# Attachment 1 – Roadway System Refinement Details

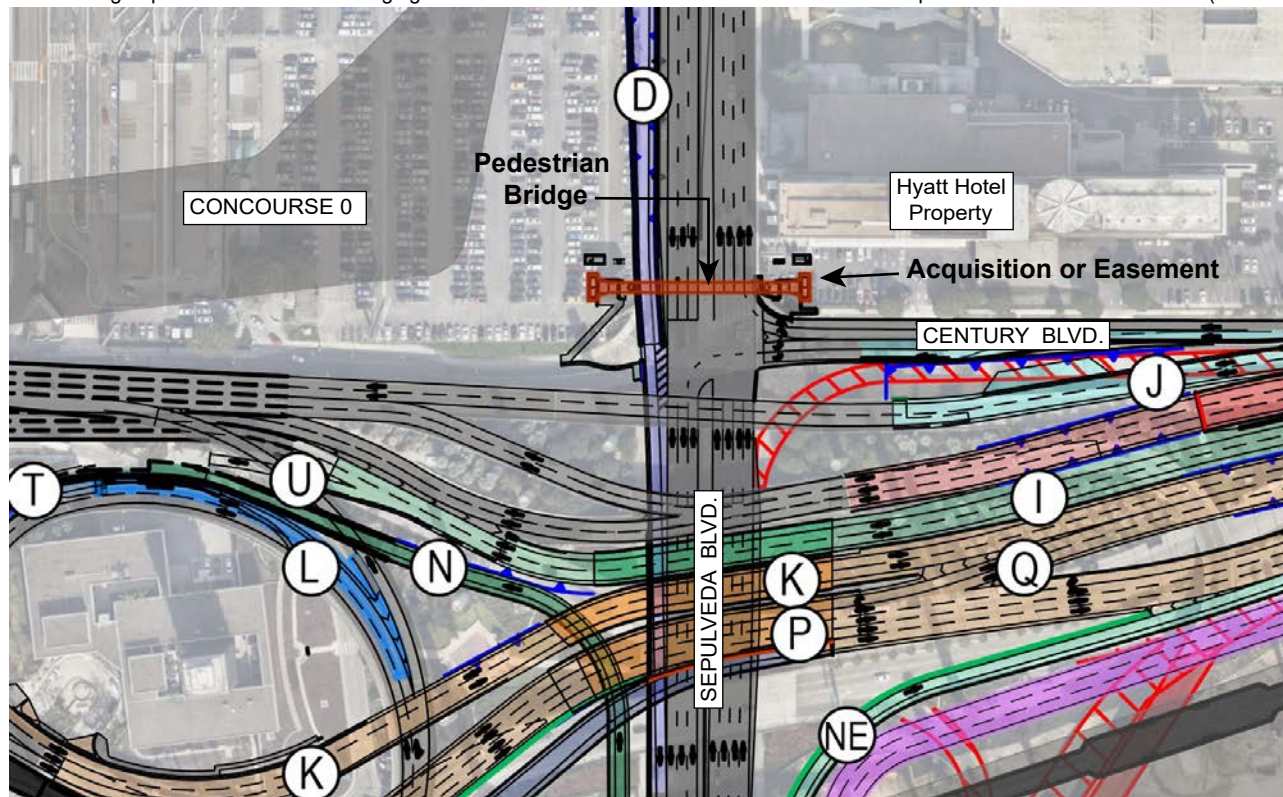
**Image 11:** A pedestrian bridge would be added over the northern leg of the intersection of Sepulveda Boulevard and W. Century Boulevard. An acquisition or easement would be required on the Hyatt Hotel property for construction of the pedestrian bridge.

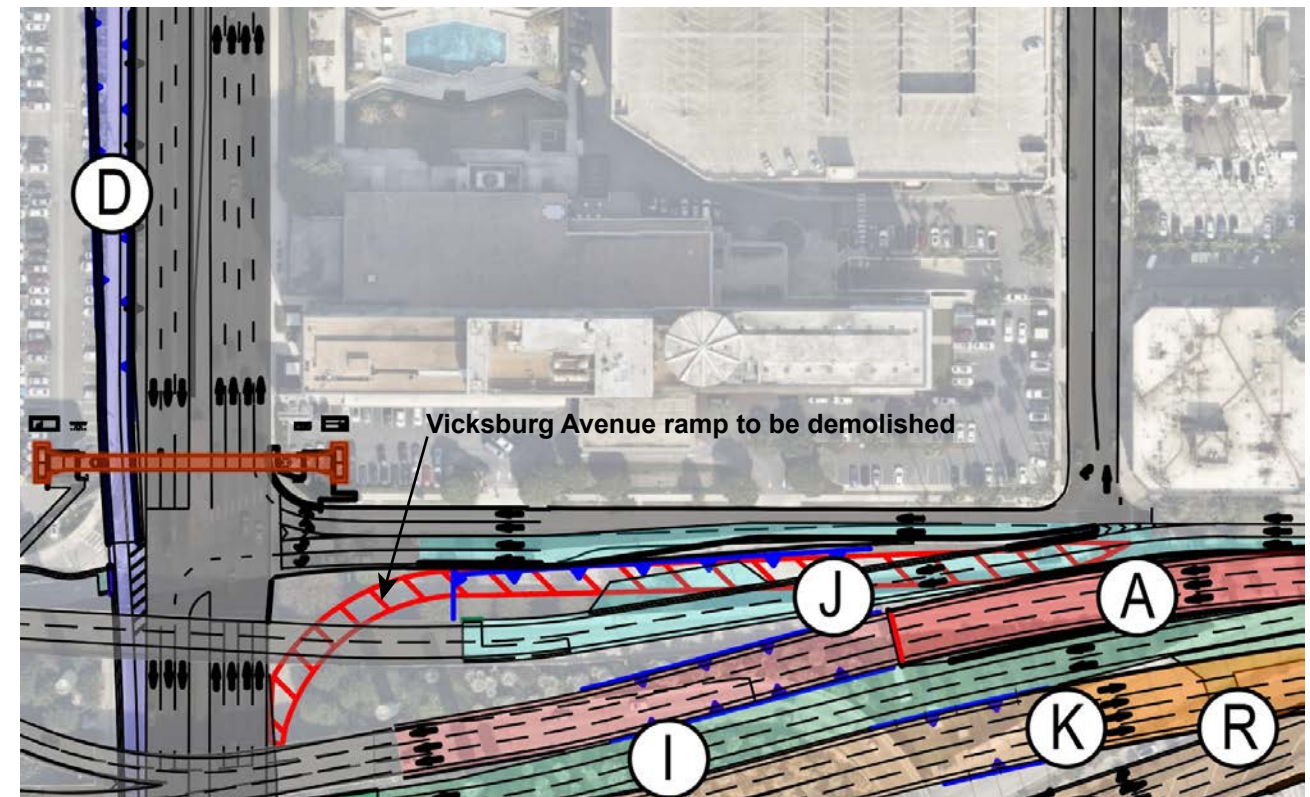
**Image 12:** Vicksburg Avenue from Sepulveda Boulevard northbound would be demolished.

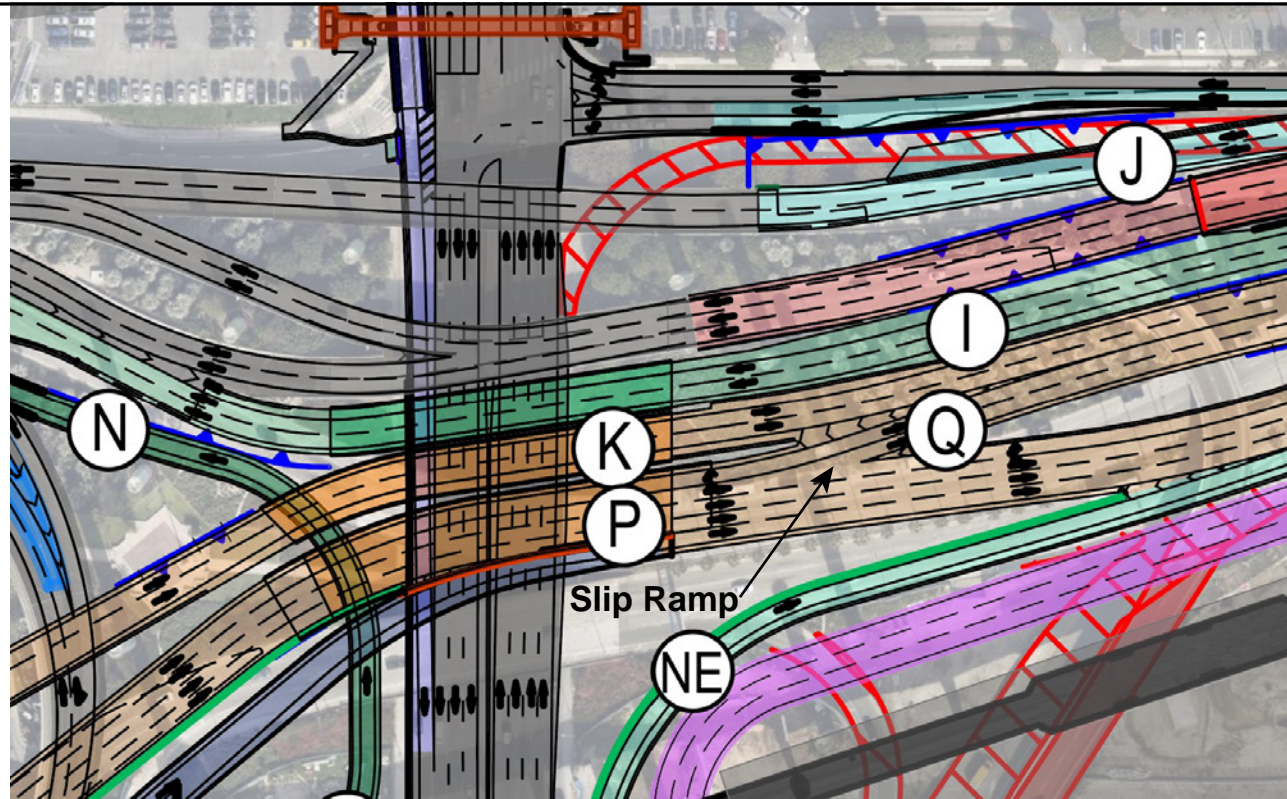
**Image 13:** Instead of a weaving section between Segments K and P, a slip ramp would be added between Segments K and P and the weaving section would be removed.

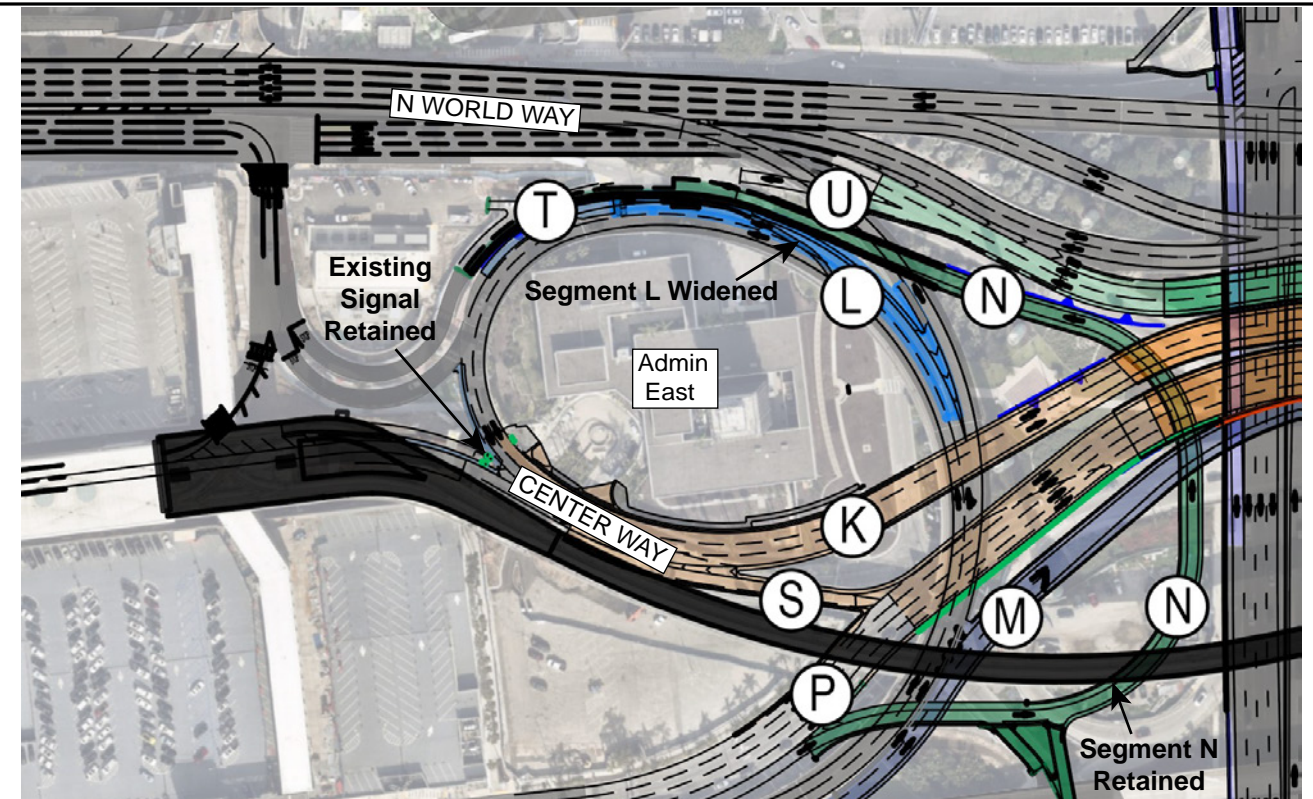
**Image 14:** Instead of full replacement as contemplated in the Final EIR, the existing loop ramp bridge, designated Segment L, would be widened. Existing signal would be retained at Center Way for pedestrian access at Admin East. Instead of reconfiguring the airport return, the existing airport return, designated Segment N, would be retained.

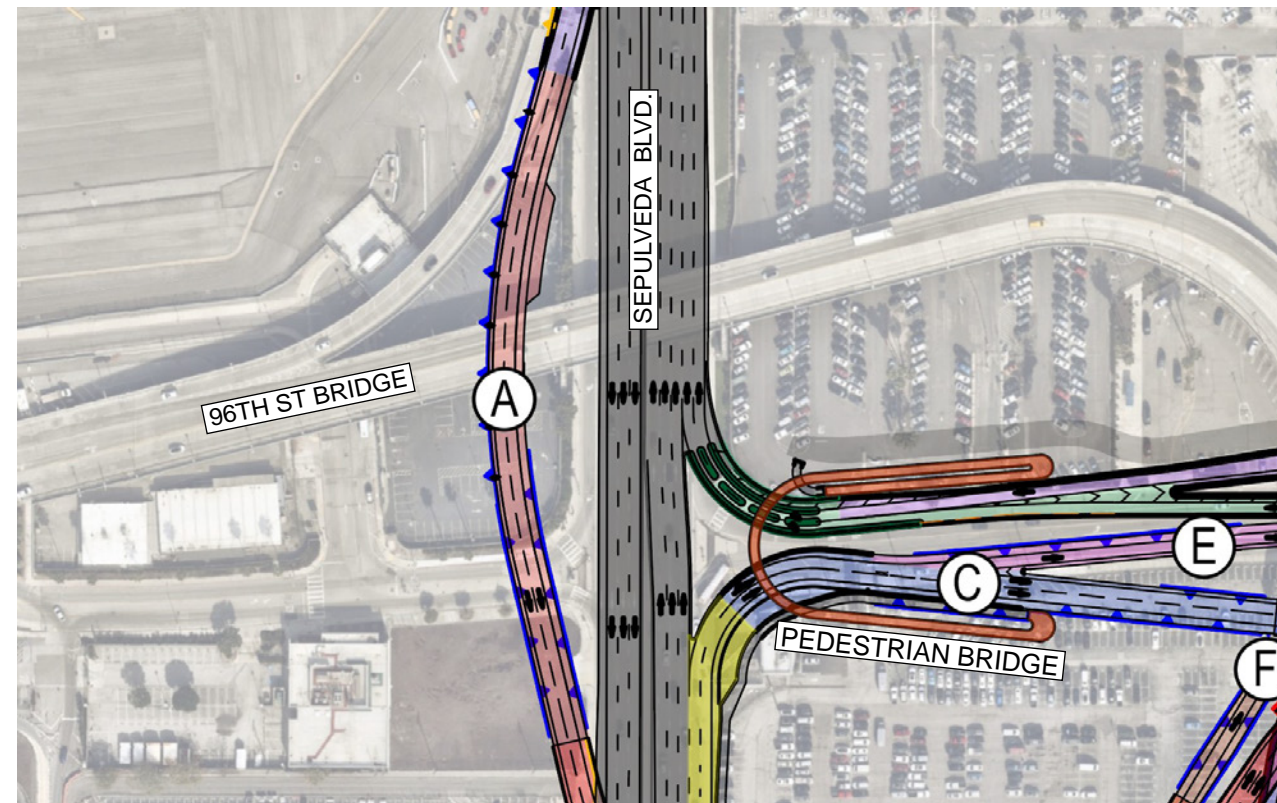
**Image 15:** The offramp from Sepulveda Boulevard southbound, designated as Segment A, would be realigned so that it would not conflict with existing support columns under the 96th Street Bridge.
